**PLANNED UNIT DEVELOPMENT  
& SUBDIVISION STAFF REPORT****Date: August 4, 2011****DEVELOPMENT NAME**

Airport Waffle House Subdivision

Planned Unit Development Approval to allow multiple buildings on a single building site, with shared access and parking between two building sites, and Subdivision approval to create 2 lots from one metes-and-bounds parcel.

# SITE PLAN

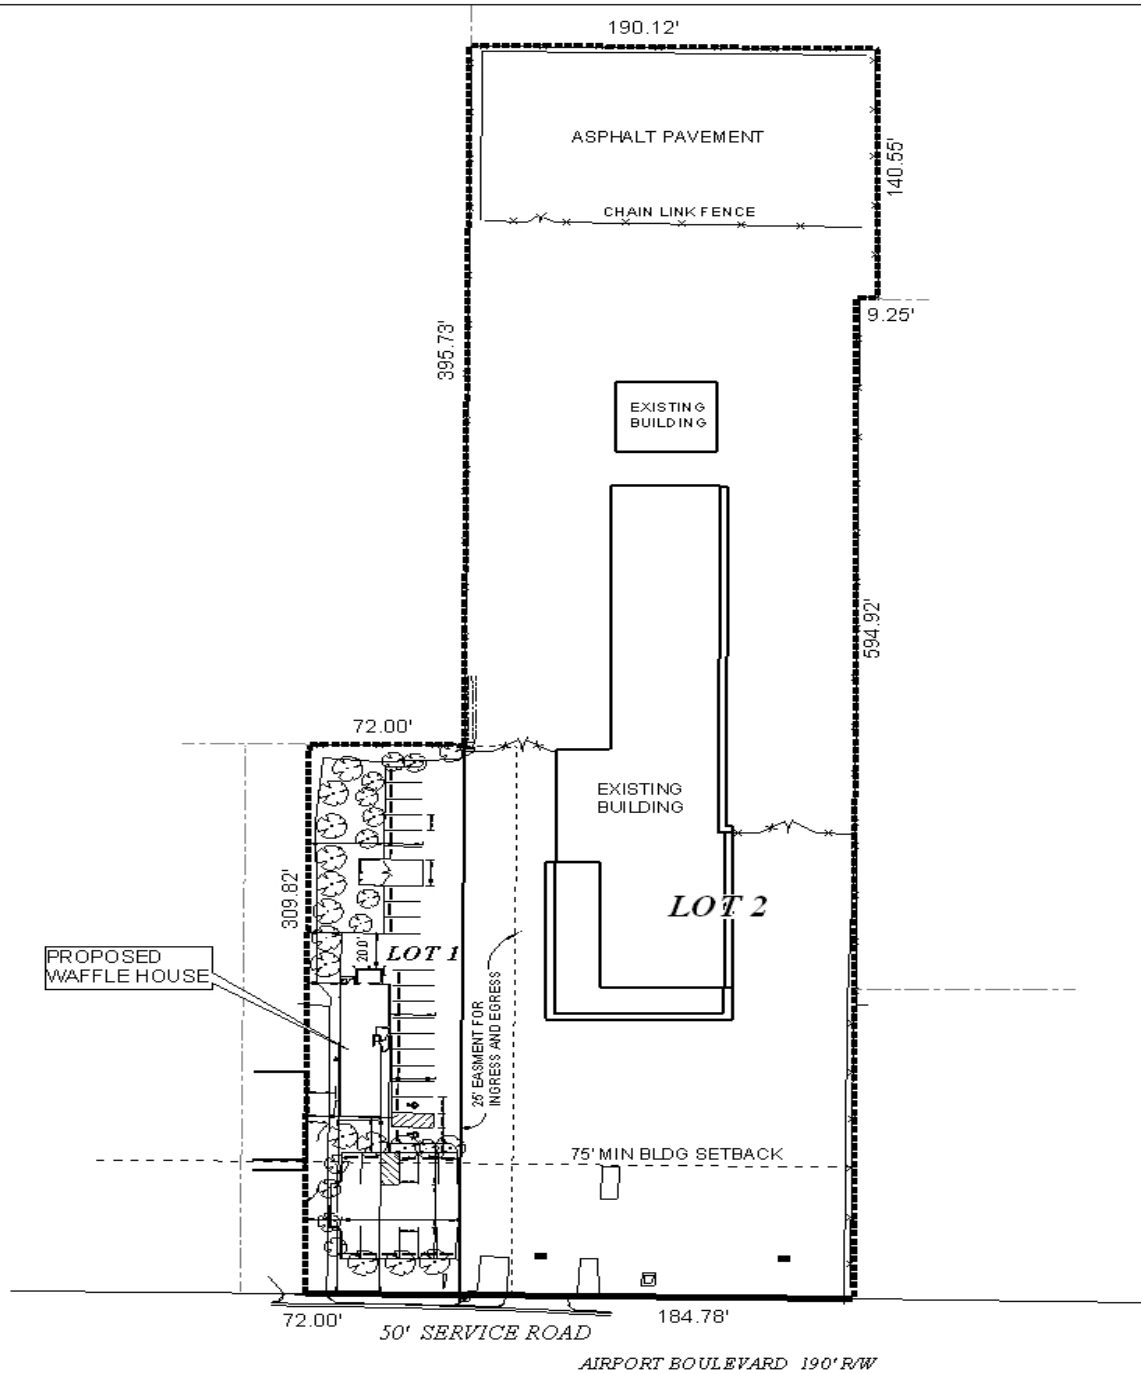
The site has marked, paved parking which serves the existing buildings currently being used as an automobile sales location. However, it should be noted that the only parking shown on the PUD site plan is proposed to specifically serve the new restaurant. Before the site plan can be approved, it should be revised to show the layout of all existing and proposed parking for the site to ensure that adequate size, spacing, number and layout exists to meet the minimum parking requirements for both sites as set forth in Section 64-6.A.6. of the Zoning Ordinance.

The proposed parking area will be accessed via a shared two-way curb-cut that is 25' wide. Reviewing aerial photos of the site reveals that there is an existing curb cut on the East side of

the property that is not shown on the site plan. This should be removed and the area landscaped. It also appears that the site shares access to the site immediately to the West: this adjacent site should also be made a part of the PUD application, or access between these sites should be eliminated.

Landscaping is illustrated for the newly proposed restaurant; however, no existing landscaping for the automobile sales business is illustrated. The site plan should be revised to depict compliance with the tree and landscaping requirements of the Zoning Ordinance, as well as the per-unit landscaping requirements of the PUD regulations.

A dumpster appears to be depicted on the site plan behind the restaurant, but is not labeled. If a dumpster is used for the automobile sales business, it should be shown as well, or a note placed on the site plan that curb-side pickup is used instead. All dumpsters proposed should be easily accessed, illustrated on the site plan, labeled, and screened with a 6' high privacy fence or wall.

It should be noted that per Section V.A.8. of the Subdivision Regulations, buffer plantings or fences must be provided for all commercial developments that are adjacent to residential areas. The subject property is bordered by three residentially zoned properties with the following uses: to the North, a church with a day care; to the East, a school; and to the West, a school. It appears that existing vegetation may fulfill the buffer requirements adjacent to the church and the Western school; however it seems there is no vegetation to buffer the Eastern school. The site plan should be revised to illustrate a proper vegetative buffer or 6' privacy fence.

- 1) revision of the site plan to illustrate all parking to be provided on site.
- 2) inclusion of the property located to the immediate West as part of the PUD (showing parking, total building area and use, footprint area, landscape area, etc), with owner approval and new labels and postage for the entire notification area to be provided to Planning by Wednesday, August 10<sup>th</sup>, or revision of the site plan to eliminate shared access between the lots;

- 3) revision of the site plan to depict elimination and landscaping of any curb-cuts determined unnecessary for the development;
- 4) revision of the site plan to depict compliance with the tree and landscaping requirements of the Zoning Ordinance, as well as the per-unit landscaping requirements of the PUD regulations, and potentially provision of a statement about the innovative nature of the development to explain why not all of the 60% of the 12% of the required landscaping can be placed within the frontage area (if this is the case), and explaining how it will be accommodated elsewhere within the development;

- 5) revision of the site plan to depict / calculate site coverage area for any portion of the site covered by a roofed structure;
- 6) revision of the site plan to include illustrate the provision of all screened dumpsters, or placement of a note on the site plan stating that dumpsters will not be provided as part of the development;

- 7) revision of the site plan to illustrate a proper 10' wide vegetative or 6' privacy fence buffer in compliance with Section V.A.8. of the Subdivision Regulations.
